# BANNOCKBURN SOUTH EAST PRECINCT STRUCTURE PLAN

Draft Amendment C107gpla Exhibited Documentation  
Ramsey Property Group Submission  
June 2025

Figure 2 Suggested Alternative SWMS Layout (see Figs 3-6 for details)

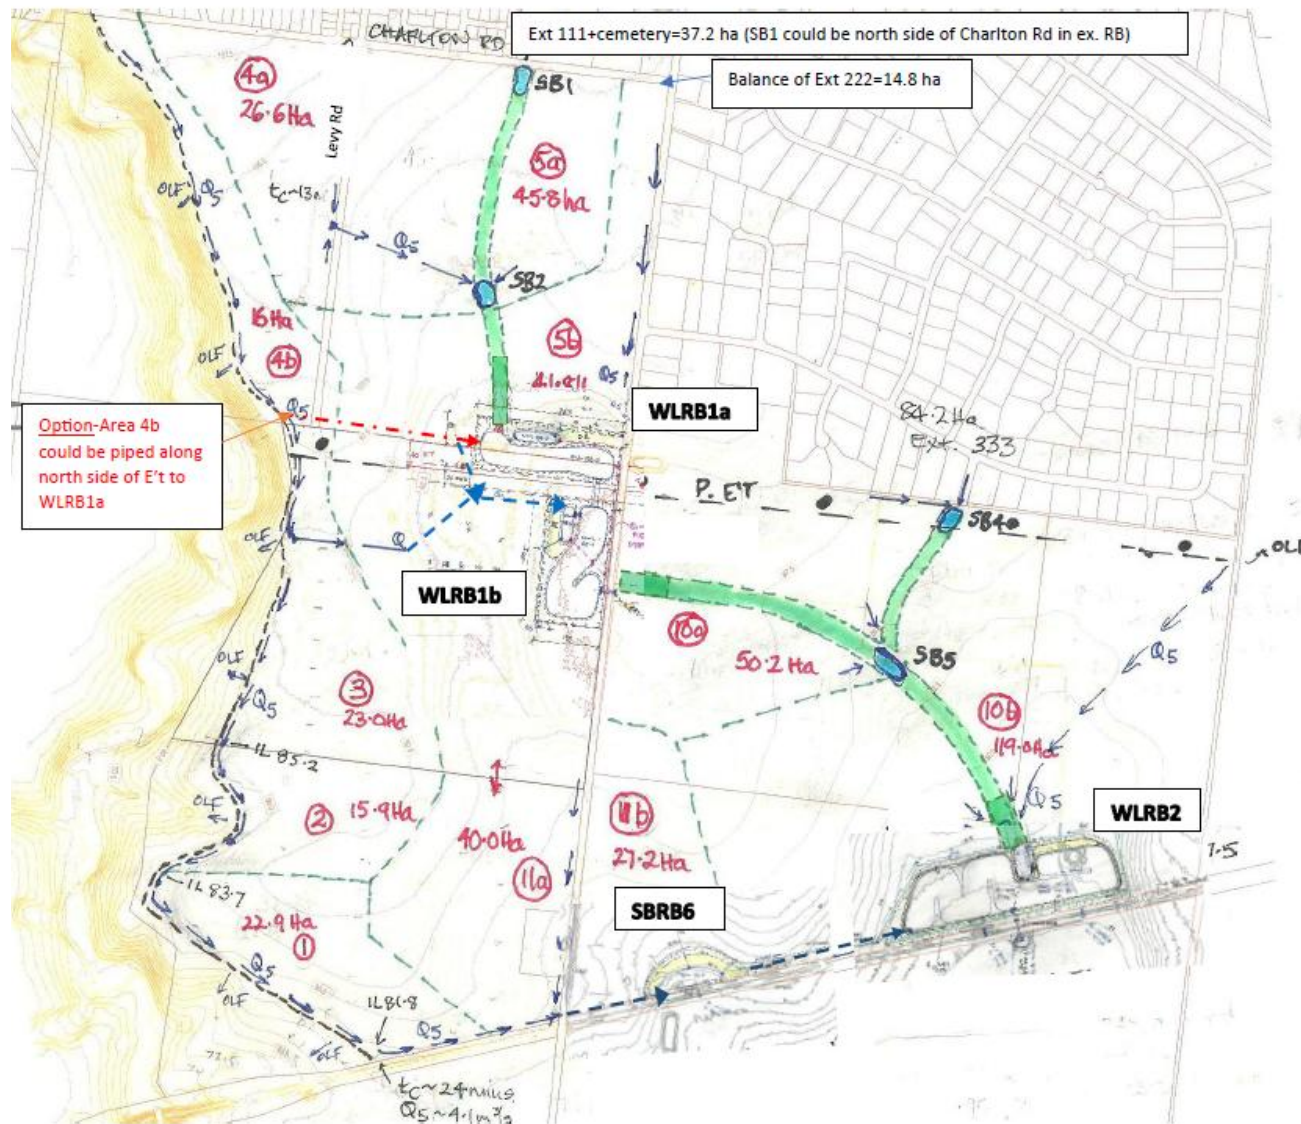
14. All sediment basins can be safely located online in waterways where shown. It is straightforward to design these to comply with velocity limits and to incorporate systems to take the basins offline for maintenance. Extra space is included in the landtake estimates (in 11 and 12 above) over and above waterway reserve areas, to provide for these considerations.

15. All wetlands incorporate standard Q1-4EY bypasses of macrophyte zones so they are effectively offline in hydrologic/hydraulic terms.
16. The railway crossing at the outlet from WLRB2 is a submerged syphon-refer to longitudinal section on Figure 5. This solution has been successfully used for the main Geelong Outfall sewer crossing at Armstrong Creek.

*Figure 3 - BSEPSP Arterial Road Cross Section*

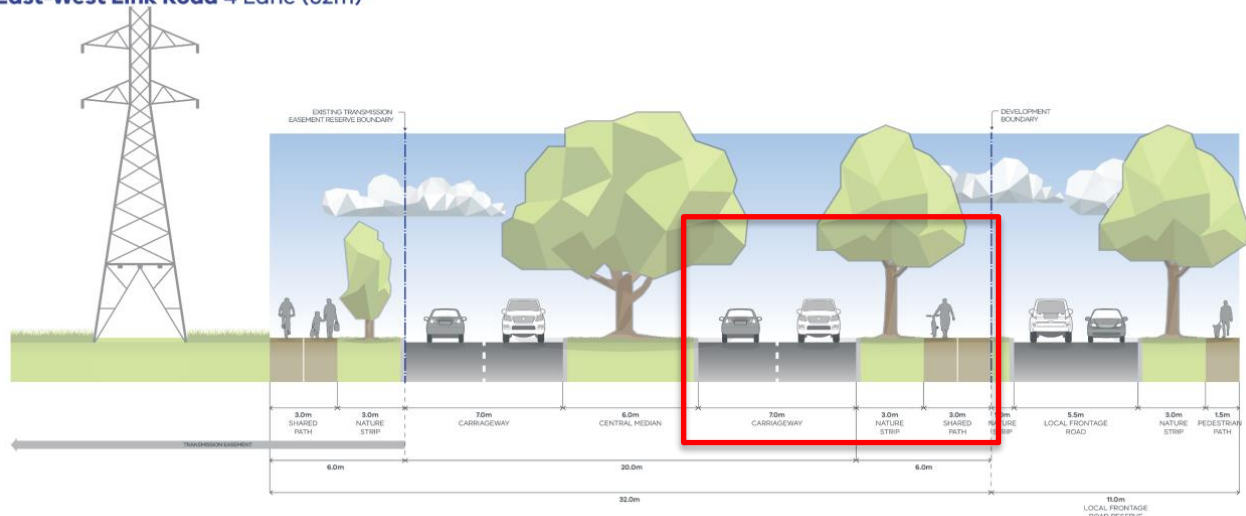
Figure 3 illustrates the assumed extent of the interim arterial road cross section within the BSEPSP, while Figure 4 presents the corresponding VPA benchmark cross section. As highlighted, the two cross sections are consistent in scope and design, thus, there is no clear justification for the higher cost per metre.

Figure 5 - Bannockburn Growth Plan

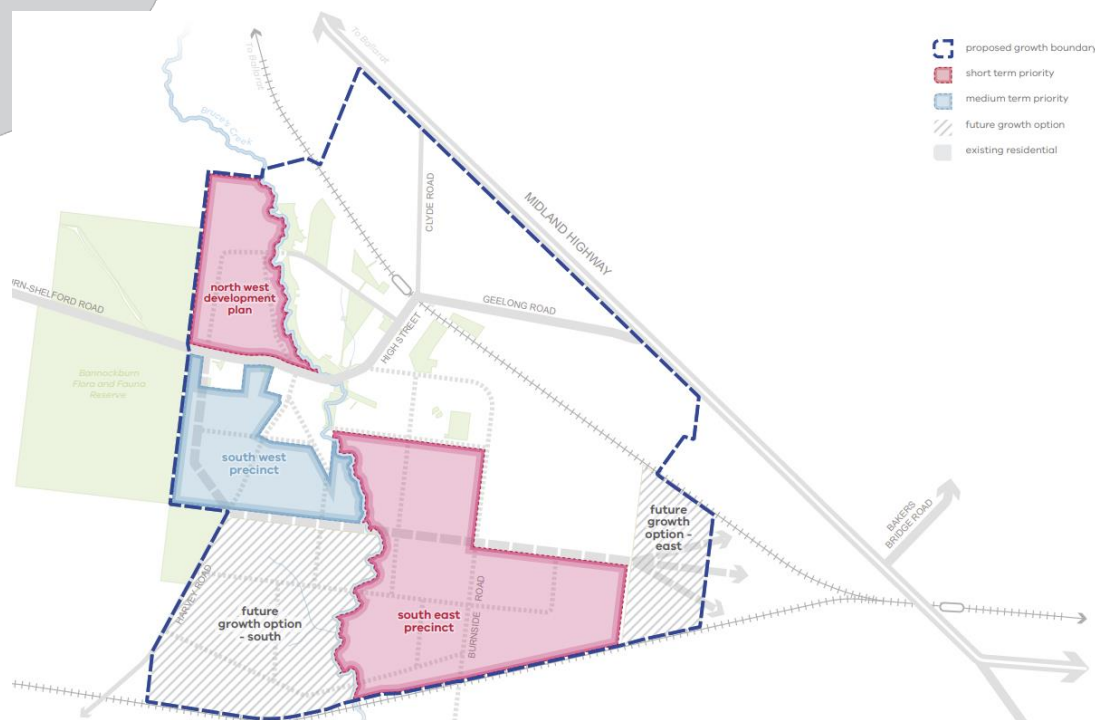
There is no clear evidence supporting the allocation of 50% of the bridge project cost to the BSEDCP. It appears that the remaining 50% may have been attributed to the "Future Growth Option – South" and/or the Bannockburn South West Precinct, as outlined in the gazetted *Bannockburn Growth Plan (BGP)* (refer to Figure 5).

Figure 2 of the gazetted *Bannockburn Growth Plan (BGP)* outlines a "medium growth model" requiring the delivery of an additional 5,500 dwellings by 2050 in Bannockburn. According to the BGP, the three identified short-to-medium term growth areas, being Bannockburn North West, South East and South West, are expected to deliver a combined 6,192 dwellings.

The BGP was developed on an average housing density of 12 lots per ha of net developable area (NDA), whereas the target for BSEPCP has been set at 15 lots per ha of NDA. This revised housing density will increase the number of lots delivered in the three precincts to circa 7,740, some 2,240 more than the 2050 housing prediction.

Notwithstanding, if the bridge project were to remain in the PSP, a needs analysis should be conducted to determine the true nexus for delivery of this significant project. This will provide a more reasonable apportionment figure based on evidence.

*Figure 6 - Arterial Road Cross Section*

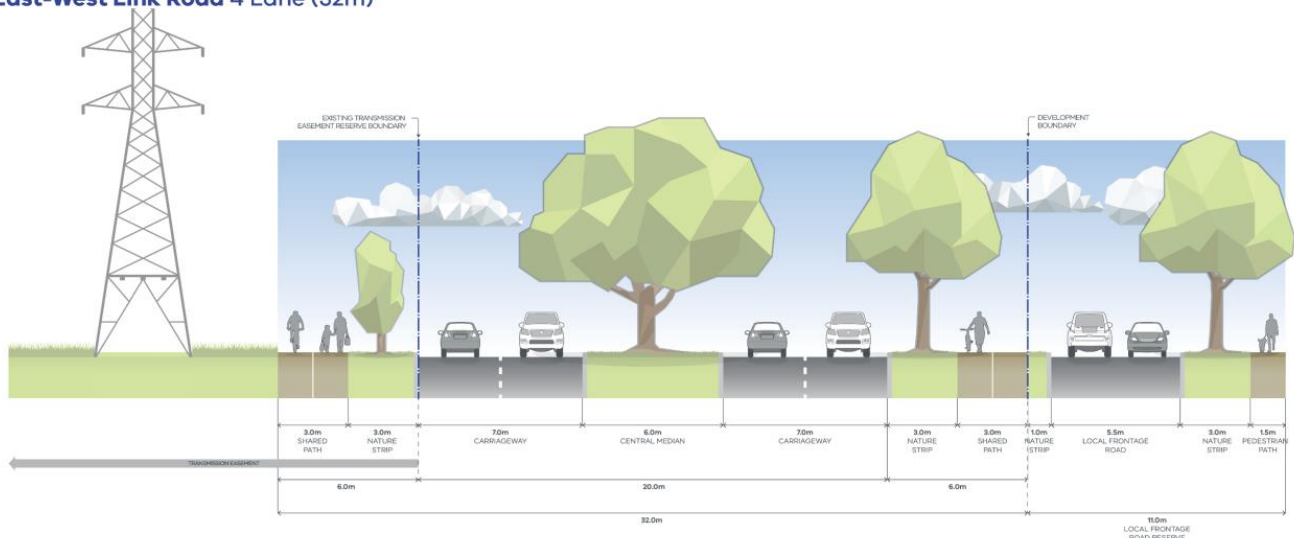
Figure 6 shows the proposed cross section of the arterial road. Notably, 6m of the cross section is located within the Ausnet High Voltage Transmission Easement, 20m of the cross section is the dual carriageway (including 6m wide median), and there is another 6m verge (including shared path) on the development side.

It is unclear how the land acquisition has been calculated. It appears that land associated with the 20m wide dual carriageway has been included in the funding, whilst the 6m verges to the north and south have not. The exclusion of land contained within the Transmission Easement is appropriate, as this land is undevelopable.

However, the land required to deliver the 6m verge on the south side of the arterial road should be funded by the DCP as the developer should not be reasonably required to deliver land outside of the "development boundary" per Figure 6.

*Figure 7 - Sections of Arterial Road recommended to be removed from the BSEDCP*

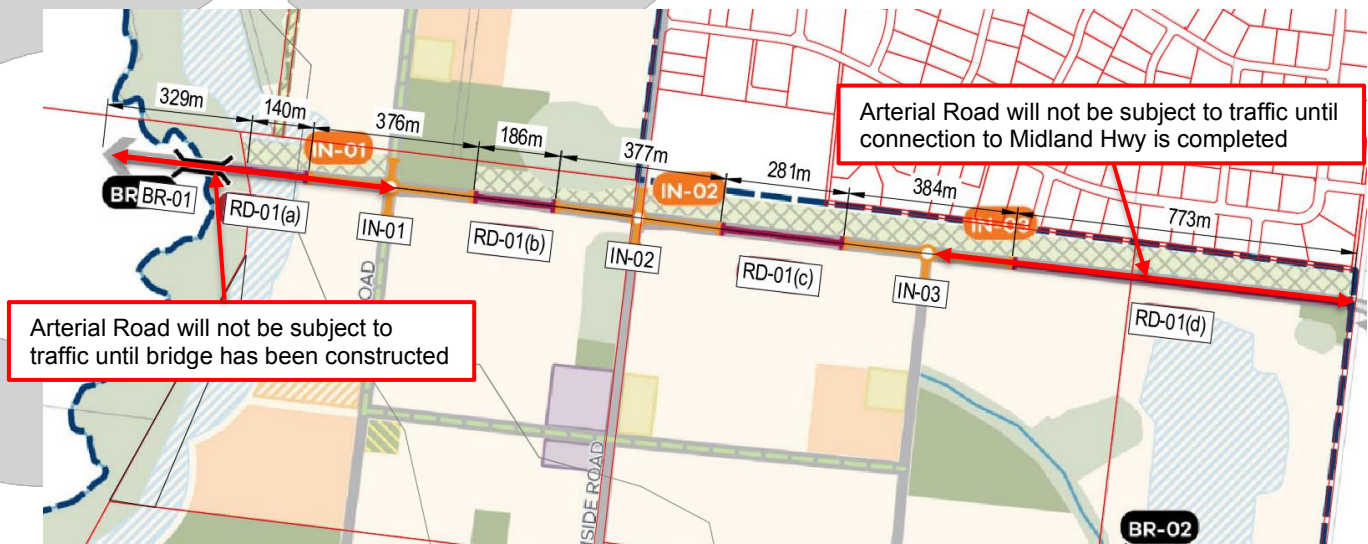
Figure 7 highlights the sections of arterial road that should not be constructed, and therefore removed from the DCP.

To be clear, the land component should remain to ensure free and open access for future delivery. This opportunity only relates to the sections of road west of IN-01 and east of IN-03.

Further to the above, consideration should also be given to the downgrading intersections of IN-01 and IN-03 to unsignalised interim "T" intersections. These intersections should be designed to allow for seamless future upgrades to a signalised standard in the future, without requiring significant rework.

**Recommendation #3 – Remove sections of RD-01 west of IN-01 and east of IN-03 & downgrade IN-01 & IN-03 to unsignalised intersections.**

## **1. Ash Row Claret Ash and Desert Ash**

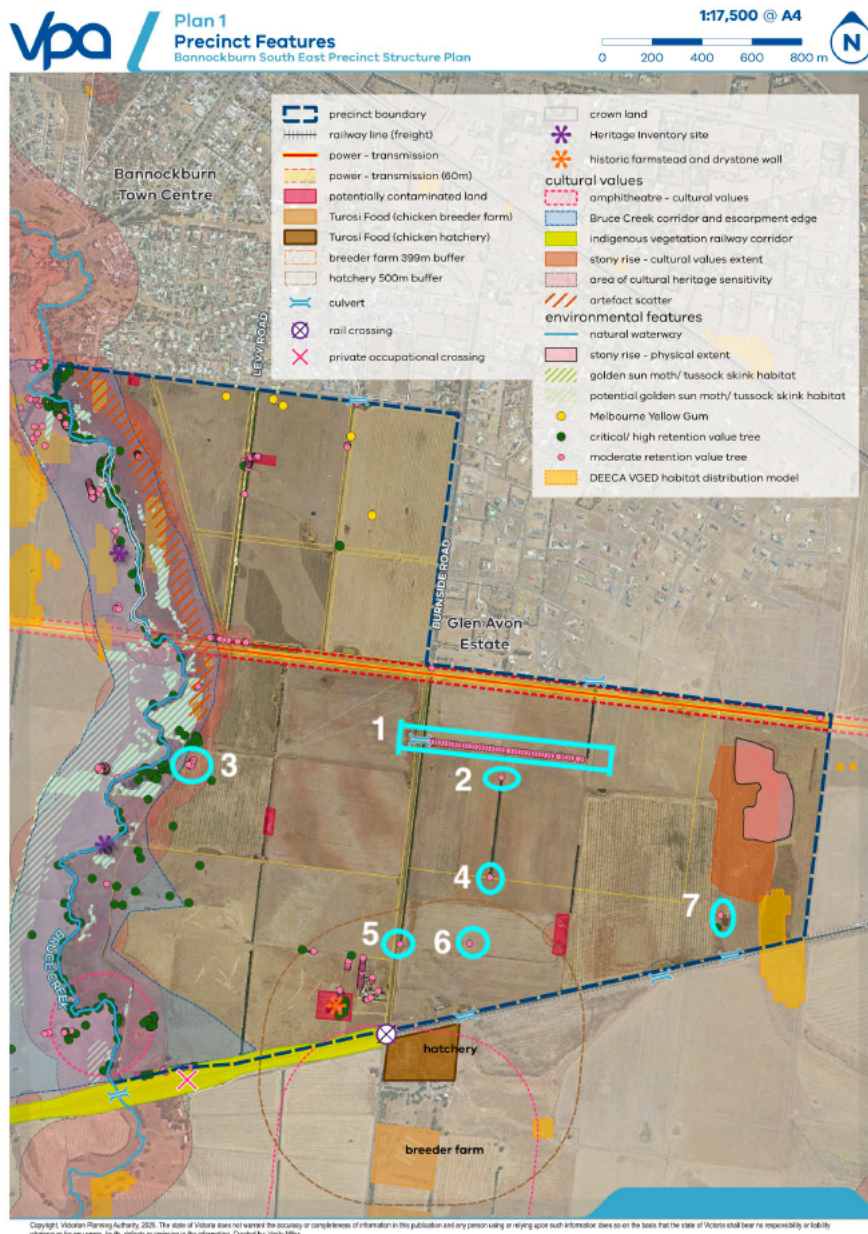
In September 2022, RPG identified a number of medium retention trees which are weeds or similar to be removed and submitted to the VPA requesting removal of these trees from the Precinct Features Plan as moderate retention. We again request the removal of the label of Moderate Retention for these trees.

1. It is noted that the desert ash (*Fraxinus angustifolia* subsp. *Angustifolia*) is listed as an environmental weed of Very High Risk in Victoria.
  2. Any requirement to retain these trees and the existing surface levels in their vicinity will result in considerably constrained designs and efficiency in their footprints and capital costs. These trees are shown in photo 3.
- It is considered that these are all poor planning, aesthetic and environmental outcomes. It is strongly recommended that these trees not be listed for retention.
